Access Compliance Report

Public Rights-of-Way

Intersection ID: 13056	Main Street: S_MINT_ST	Cross Street: W_BLAND_ST	Location: E
ADA ID: 3B82B48502DD	Ramp Type: PerpDiag	Initial Pass/Fail: Fail	Overall Compliance: No
		Severity Score: 8.75

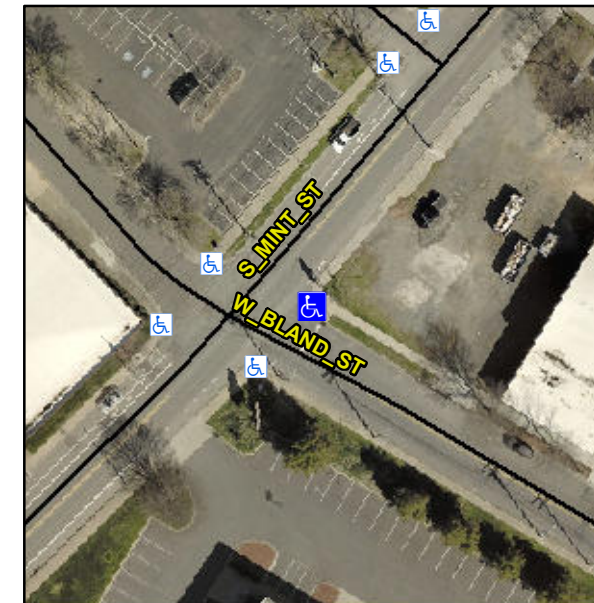
Compliance	Description	Data	Compliance	Description	Data
N/A	Ramp Length (in)	59.0	Yes	Ramp Slope (%)	6.7
No	Ramp Width (in)	43.0	Yes	Ramp XSlope (%)	0.0
N/A	Flare Type LT	N/A	N/A	Flare Type RT	N/A
N/A	Flare Slope LT (%)	N/A	N/A	Flare Slope RT (%)	N/A
N/A	Flare Traversable LT?	N/A	N/A	Flare Traversable RT?	N/A
N/A	Landing Length (in)	N/A	N/A	DWS Provided?	N/A
N/A	Landing Width (in)	N/A	N/A	DWS Contrast?	N/A
N/A	Landing Slope (%)	N/A	N/A	DWS Length (in)	N/A
N/A	Landing X Slope (%)	N/A	N/A	DWS Full Width?	N/A
N/A	Landing Curb? (Y/N)	N/A	N/A	DWS Offset (in)	N/A
N/A	Shared Landing?	N/A			
N/A	Gutter Ponding?	N/A	N/A	Gutter Slope (%)	N/A
N/A	Gutter Lip Ht (in)	N/A	N/A	Gutter X Slope (%)	N/A
N/A	Painted X Walk1?	No	N/A	Painted X Walk2?	No
	X Walk 1 Direction	To NW		X Walk 2 Direction	To SW
N/A	X Walk 1 Width (in)	N/A	N/A	X Walk 2 Width (in)	N/A
	X Walk 1 Slope (%)	4.7		X Walk 2 Slope (%)	5.8
	X Walk 1 X Slope (%)	4.3		X Walk 2 X Slope (%)	1.2

Remove & Replace Curb Ramp With Two New Directional Ramps or Equivalent.
